**NORTH AMERICAN AVIATION • INC.**

SERVICE LETTER NO. 2

SUBJECT: PROPELLER CONTROL FRICTION LOCK

SUBJECT: SAFETY WASHERS ON MAIN GEAR RETRACTING LINKS AND NOSE GEAR  
RETRACTING CYLINDER MOUNTING STRUCTURE RIVET REPLACEMENT

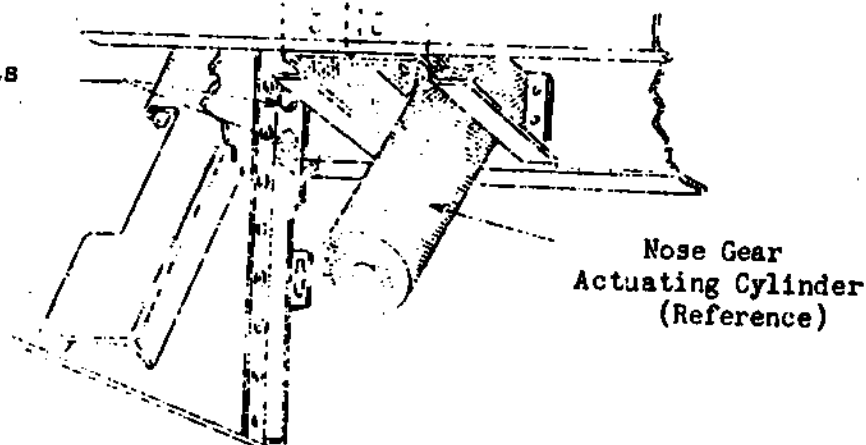
In order to preclude the possibility of the main landing gear retracting link working off of the swaged-in bearing located at strut attaching end, safety washers should be added in place of the present AN washers at the earliest convenience. The desired size of the washers should be  $5/8$ " I.D.,  $1-3/8$ " O.D. by  $1/16$ " in thickness, and may be fabricated locally from 1020 steel or equivalent. Two (2) washers are required per airplane.

At the nose gear retracting cylinder attaching cross member, where ends attach to nose wheel well side spar, right hand side, upper corner (see sketch), determine if the two (2) proper  $3/16$ " high shear rivets are installed. If there are two (2)  $1/8$ " rivets, they should be removed, holes drilled out with a No. 12 drill and two (2) AN 3- bolts installed. On the left hand side, upper corner, see if the two (2) proper  $5/32$ " dural rivets are installed, if there are  $1/8$ " rivets, remove same, drill out to  $5/32$ " and install two (2) AN 442-AD5 ( $5/32$ ) rivets or drill out with No. 12 drill and install two (2) AN 3- bolts.

See Sketch.

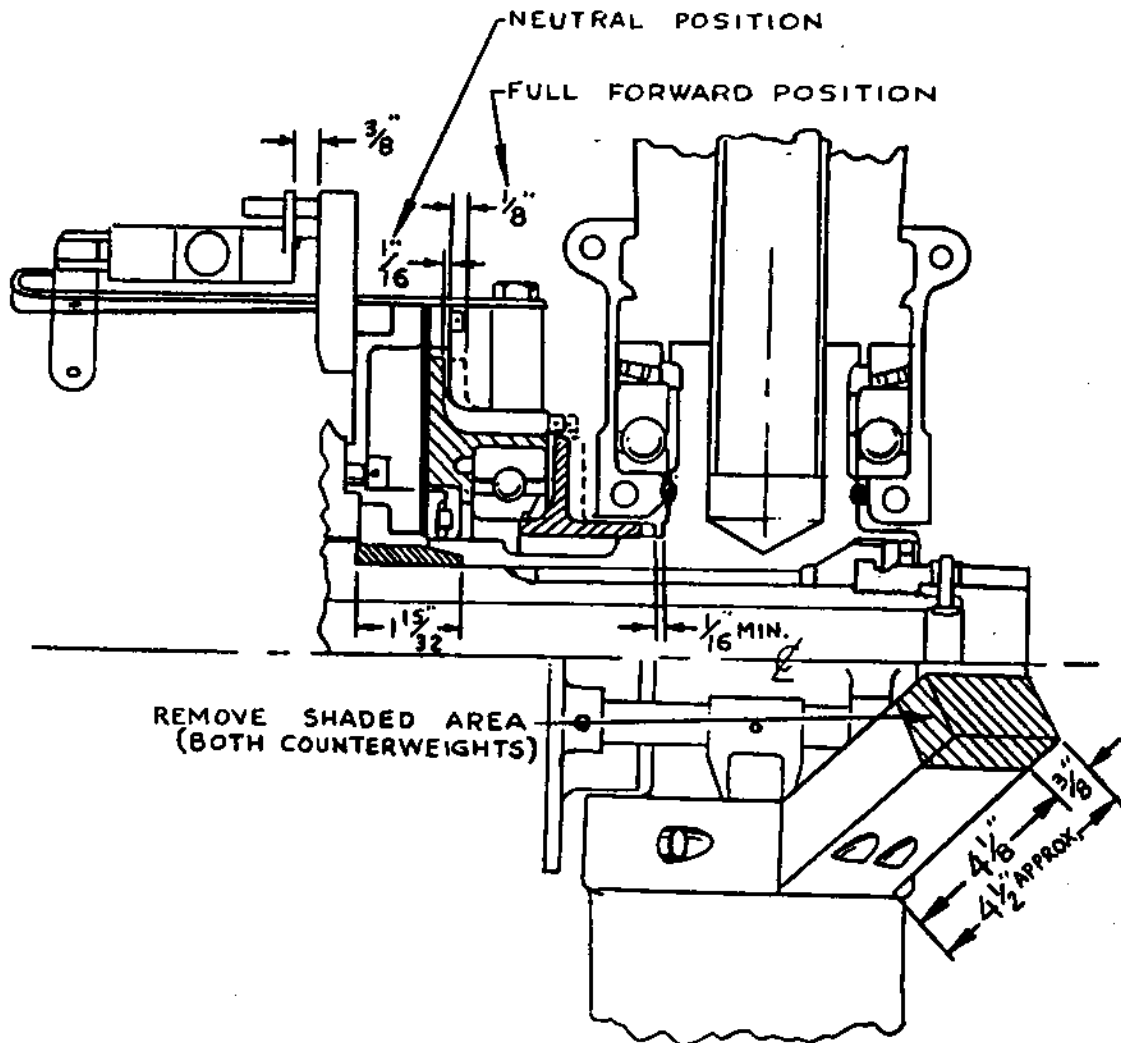
1. Measure length of rear cone as in Step 1 of Part A, if a spacer is found behind a cone that measures 1-15/32 inches, remove spacer and do not use. The use of varying thickness shims behind the rear cone as described above may position the -7 propeller hub out too far on the engine shaft and so preload the propeller diaphragm and effect its deflection during propeller operation. If proper length cone is used (1-15/32 inch) and the Hartzell installation instructions carefully followed the required 3/16 inch maximum deflection of the diaphragm each side of neutral can be maintained. Control of diaphragm deflection is essential to prevent an unnecessary strain being put on the diaphragm. Propellers having been in service with a full length cone and additional spacer should have the hydraulic element disassembled and the diaphragm inspected for possible rupture or signs of weakness in area near clamping rings. If signs of rupture or weakness are found, diaphragm must be replaced before propeller can be put back in service.

2. Install propeller on engine in accordance with instructions contained in Supplement Section X of the Hartzell Propeller Manual, third printing, dated August, 1948, exercising the utmost care in adjusting propeller control cable before attaching it to the A-117 servo valve control lever. In this regard, we quote from the Hartzell Manual. "When connecting wire to lever A-117, position piston in forward position and servo valve body  $3/8$  inch from valve plate (near mid position); also push pull control should be pulled out from dash approximately  $1/8$  inch".

3. Check for  $3/16$  inch maximum deflection of diaphragm each side of neutral by determining that the front face of the element piston is  $1/16$  inch behind front edge of diaphragm clamping ring when diaphragm is in neutral. When diaphragm is in maximum allowable forward position, the front face of piston should extend beyond front edge of clamping ring  $1/8$  inch.

SUBJECT: REPAIR - CRACKED EXHAUST MANIFOLD OUTLET CLUSTER

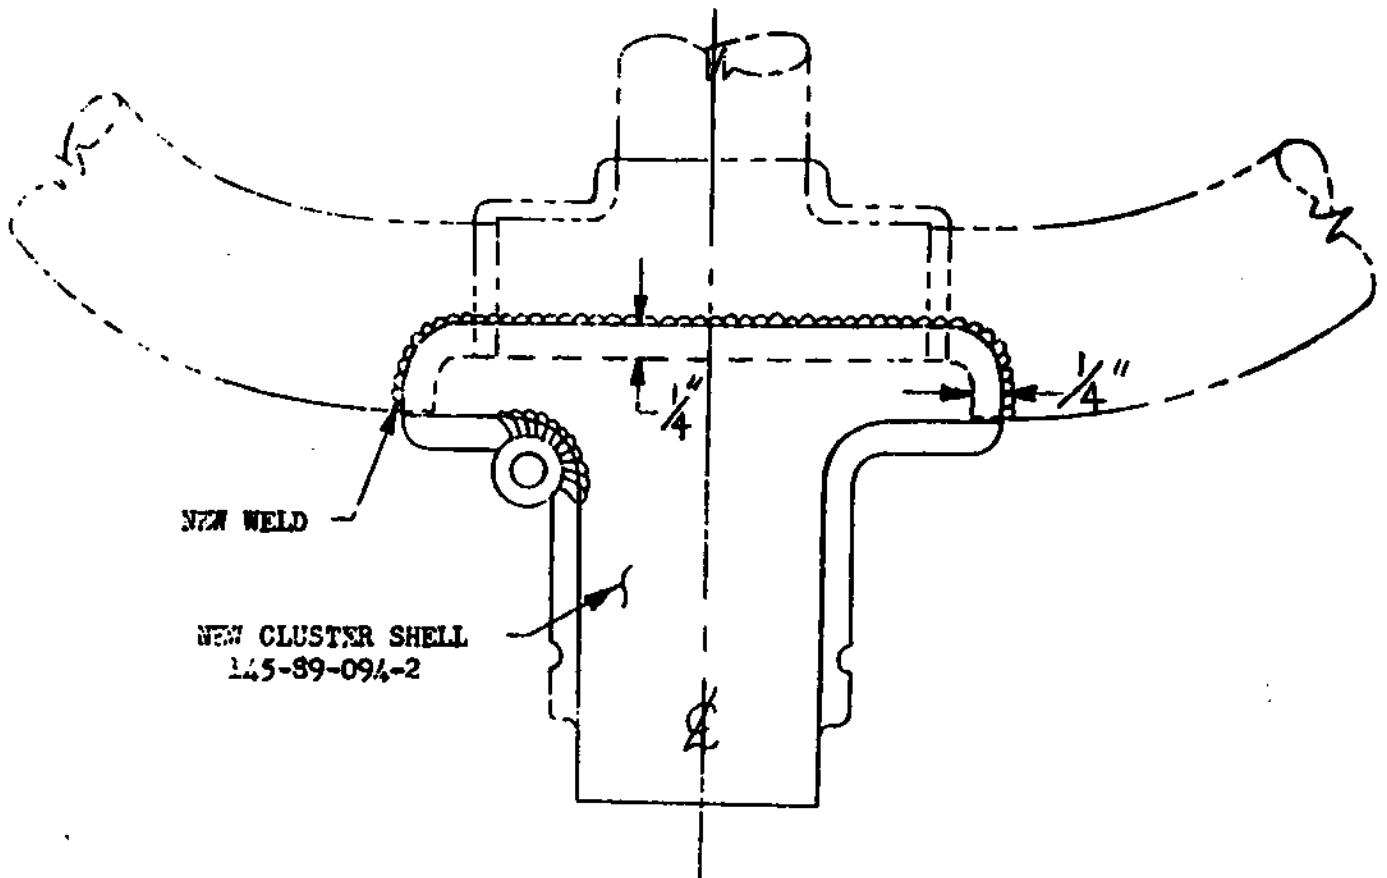
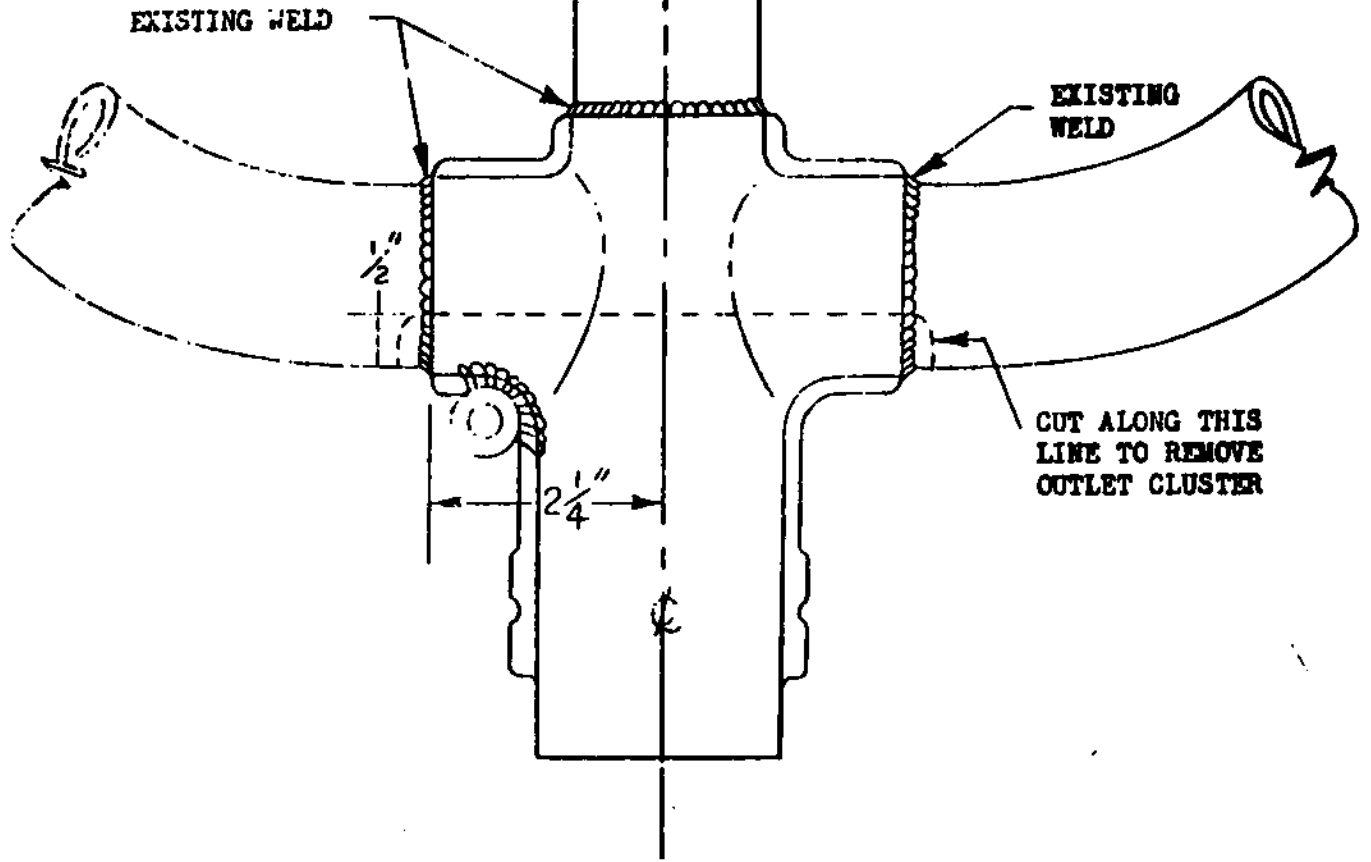
Should a condition arise wherein the exhaust manifolds crack adjacent to the attaching weld of the outlet cluster; use the following, approved, repair procedure. Ryan part No. 145-89094-2, which is necessary to accomplish this repair, may be procured from the Spare Parts Department of the Ryan Aeronautical Company.

1. Remove manifold assembly from airplane. See Navion Service Manual, page 59.
2. Cut cluster shell and attaching material from manifold as shown in illustration.
3. Place new 145-89094-2 cluster shell over the manifold cut-out. Clamp the shell to the manifold in such a manner as to line up the shell with the manifold. This alignment is critical to maintain tail pipe to cowling clearance.
4. Weld shell to manifold by using arc or gas welding rod. The weld should be gas tight.

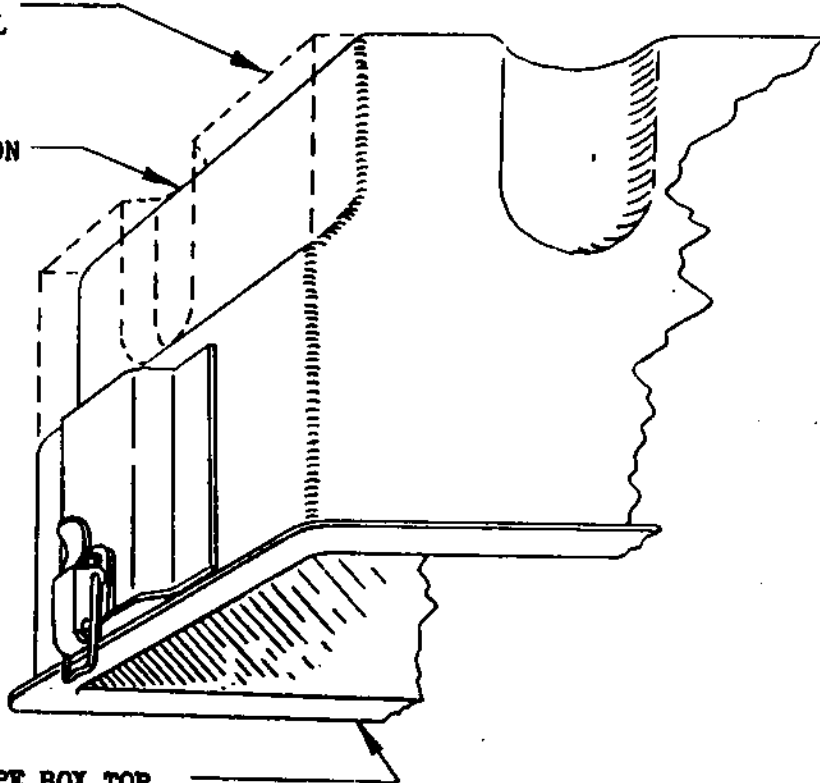
2. When recapping or retreading main wheel tires it is suggested that excessive rubber tread should not be installed so as to leave inadequate clearance between tire and wheel well flange.

**NOTE:** Clearance must be adequate for tire expansion at altitude and any foreign matter that may attach to the tire such as mud and ice; otherwise faulty gear extension may result.

EXIDE  
BATTERY

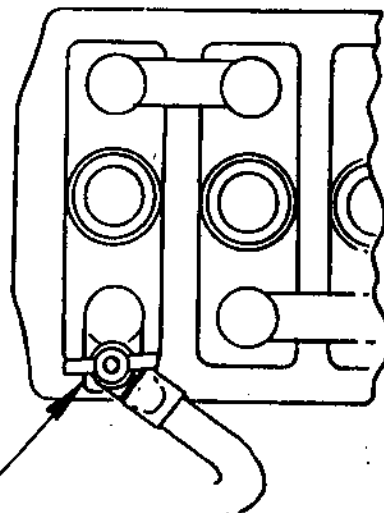
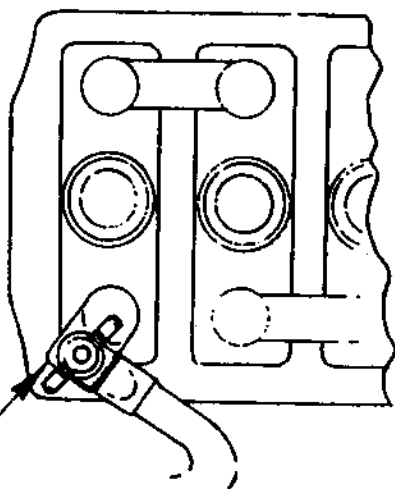
**NOTE:** Do not extend entire end as the narrowed down section was designed to hold the battery down by contacting the edges.

**SUBJECT:** OPENING OF REAR SEAT BOTTOM SPRING ATTACHING LOOPS  
CAUSED BY ABNORMAL LOADS BEING APPLIED IN CONCENTRATED  
AREAS OF SEAT

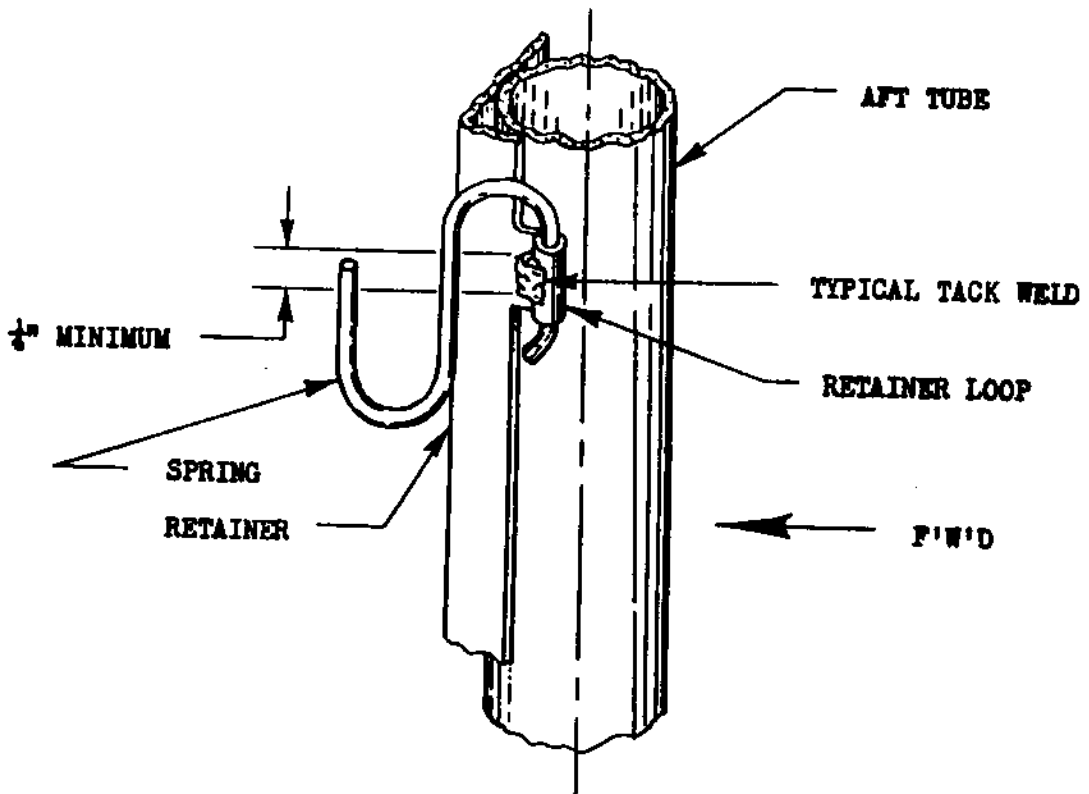
**PURPOSE:** TO PROVIDE A METHOD TO PREVENT LOOPS FROM SPREADING  
AND ALLOWING SPRINGS TO DETACH AND DAMAGE UNDERSEAT  
AUXILIARY TANK WHEN INSTALLED

To prevent rear seat bottom springs from becoming detached and resting on underseat auxiliary tank with subsequent damage, the following method of providing additional support should be accomplished at the earliest convenience or when installing the auxiliary underseat tank kit.

Figure 1. Fuel Quantity Transmitter

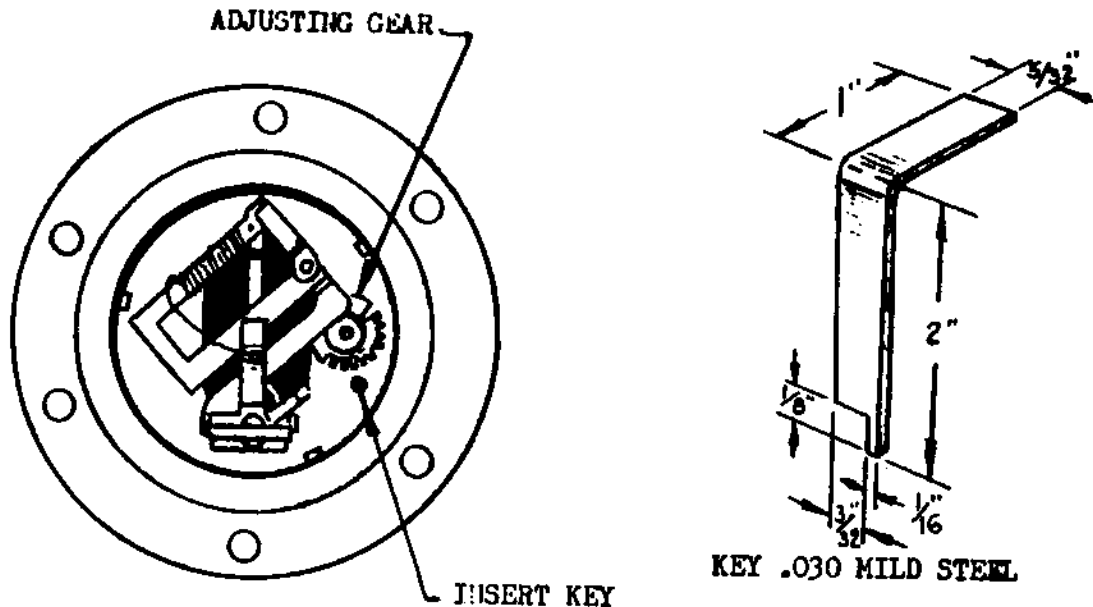
1. Drain all fuel from the fuel system.
2. Put five (5) gallons of gasoline in the wing tanks.
3. Remove cap on fuel level transmitter and adjust so that fuel level indicator reads two (2) gallons. Refer to Figure 1.
4. Replace cap and allow at least three (3) minutes for temperature to stabilize and recheck two (2) gallon reading on the gauge. It is very important to replace the cap on the transmitter securely during this check as when the cap is left off any slight air movement will affect the gauge reading. If the two (2) gallon reading is in error, remove cap, readjust and recheck as above.

NOTE: Turn adjusting gear clockwise to increase indicator reading or counter-clockwise to decrease indicator reading.

FIGURE NO. 1

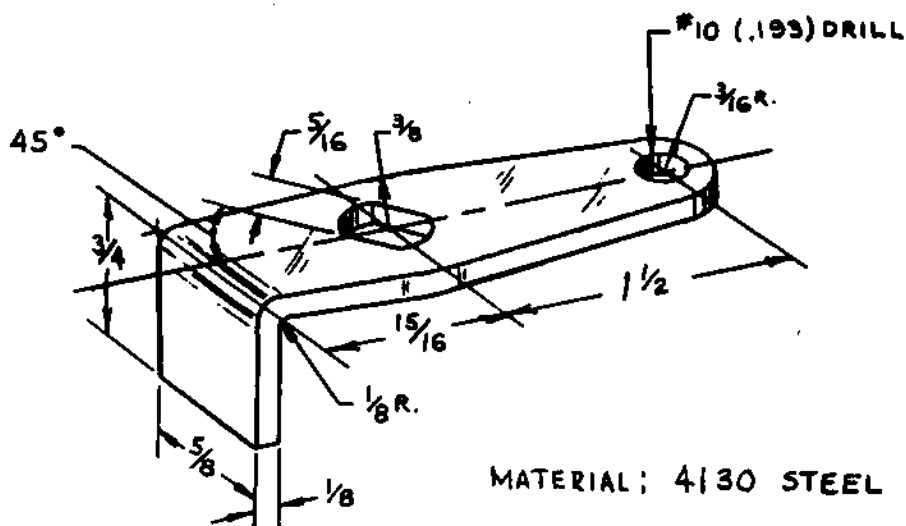
- (a) Disconnect fuel lines and flexible control to D-51 valve and remove D-51 valve.
  - (b) Fabricate a lever to replace existing valve handle and install new lever on W-7000-2D Whittaker valve. See Figure 1.

3. Install two (2) oversize "O" ring seals, Part No. AN6227-13 in the D-51 valve in the following manner:
  - (a) Remove D-51 valve from airplane.
  - (b) Unscrew "ON-OFF" control arm from valve core and disassemble D-51 valve in two halves.
  - (c) After removing the valve core, replace the two (2) "O" ring seals with AN6227-13 seals.
  - (d) Lubricate valve, then assemble and reinstall in airplane, pressure test fuel system and check D-51 valve for leaks.

**STARTER SOLENOID ADJUSTMENT  
FIGURE 1**

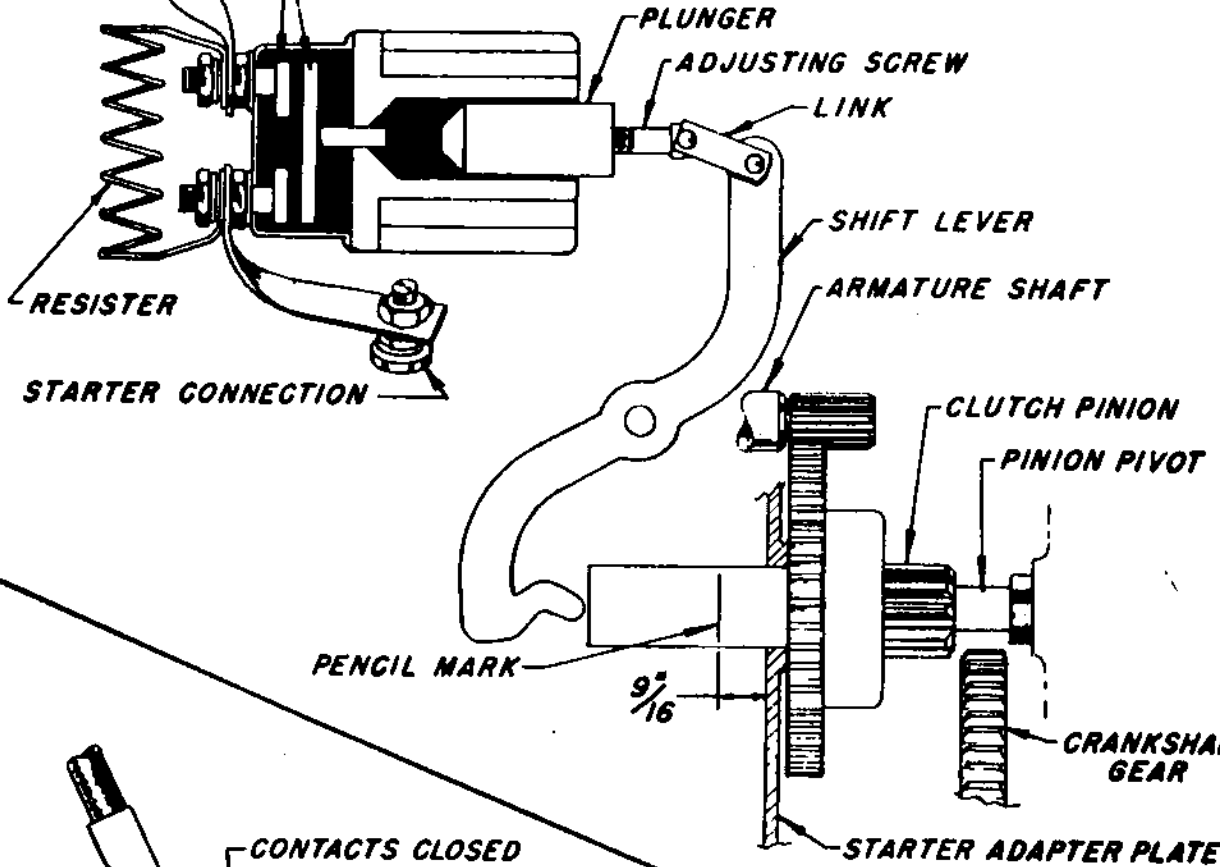
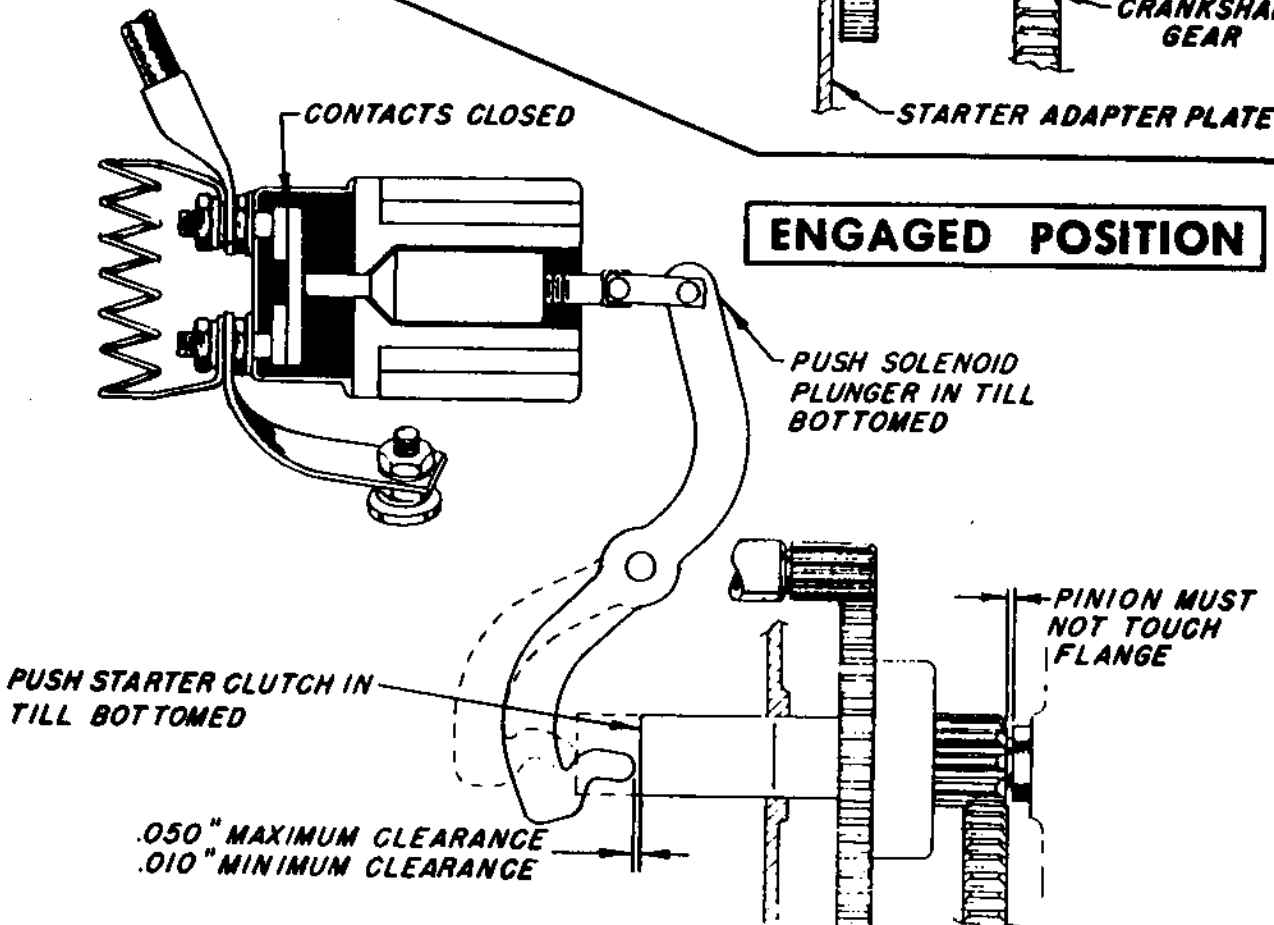
**DISENGAGED POSITION**

**ENGAGED POSITION**
